Access Compliance Report Public Rights-of-Way (Curb Ramps)

Main Street: BARBERRY_ST Cross Street: HYDRANGEA_ST Location: NW

ADA ID: RPAT211102150957 Ramp Type: Type 1 - Perpendicular Diagonal Initial Pass/Fail: Fail Overall Compliance: No Severity Score: 15

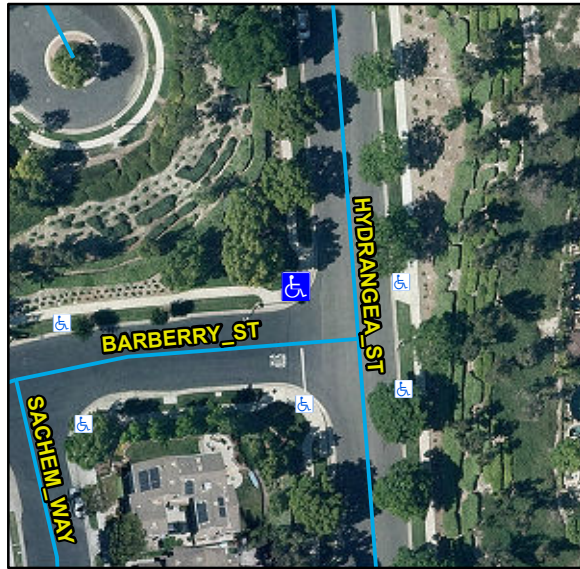
R304.2.2, R204.3, R304.5.3, STD 1115

Remove & Replace Curb Ramp With Two New Directional Ramps or Equivalent.
